Certificate of Appropriateness for
1207 Jenifer St.

June 24, 2019

Proposed Work

- Replace all windows and doors

Quote Qty: 2
Single Hung, 44.5 X 46.5, Almond

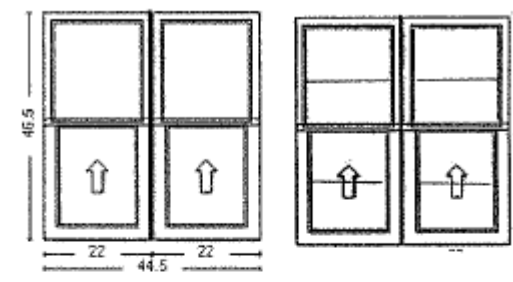
Staff believes that the standards for granting a Certificate of Appropriateness are not met due to the windows and doors potentially being repairable, and the proposed replacements not replicating the original features. As such, staff recommends that the Landmarks Commission deny the proposal.
